TOP SILKSCREEN

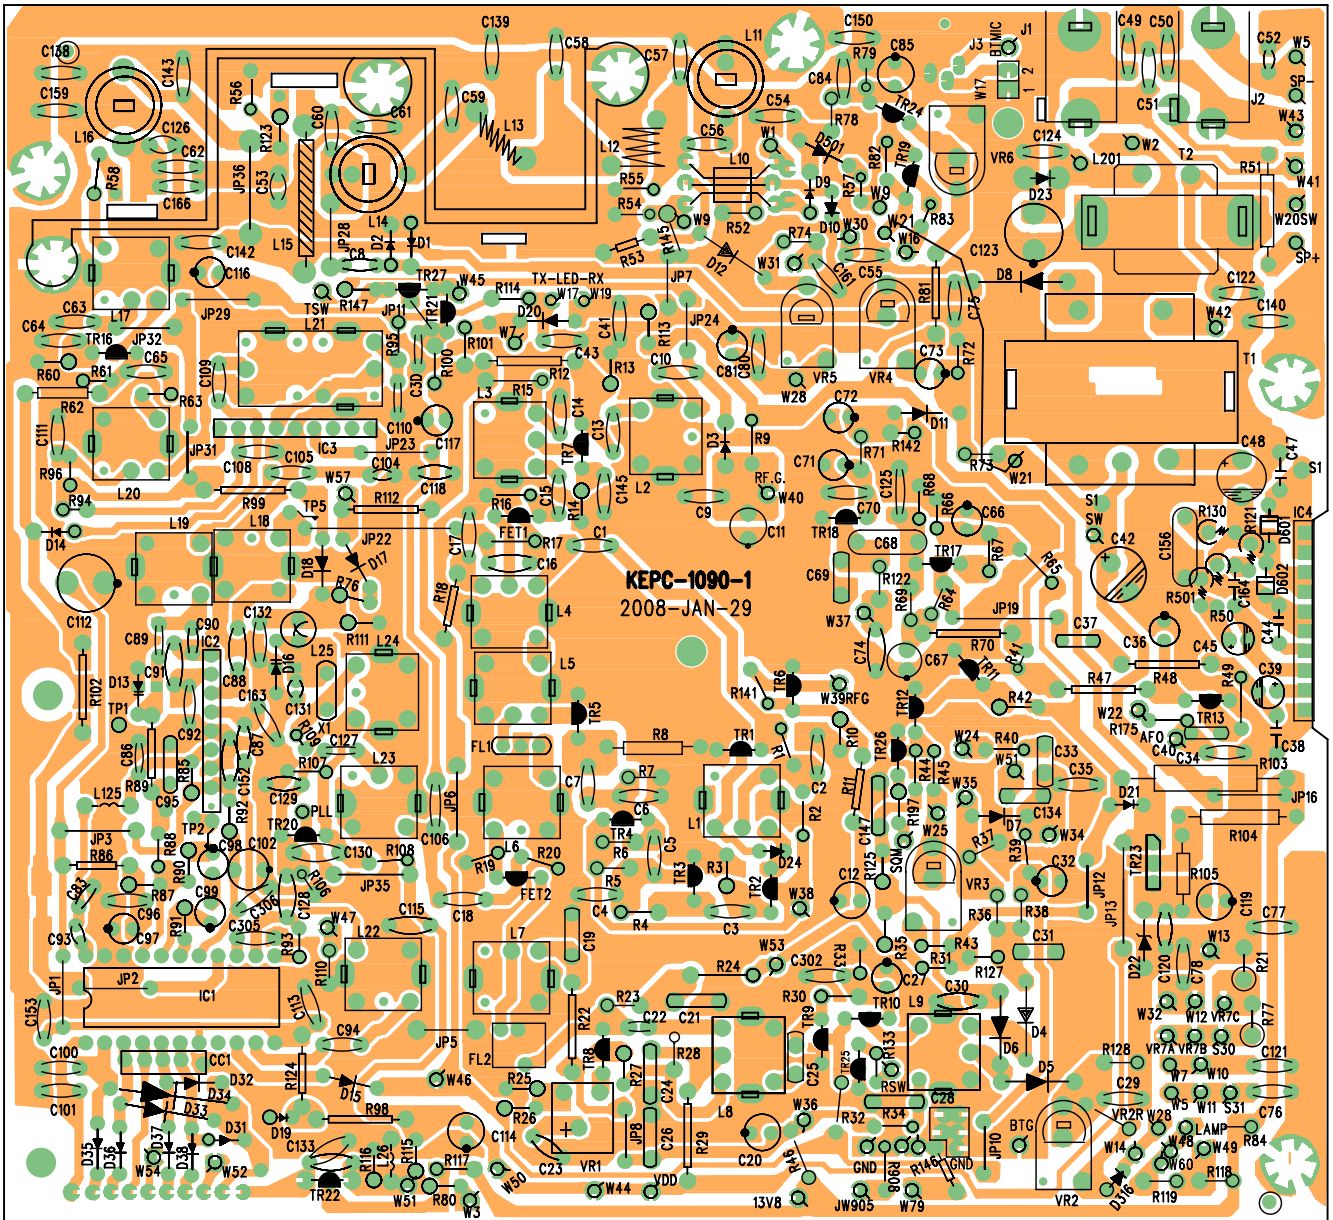
1. R117, R102 MOVED BASE ON M1; R102 CHANGED TO GER-332CBB
2. TR23 ADDED SOME COPPER AT COLLECTOR
3. JP13 FROM 11MM CHANGE TO 14MM
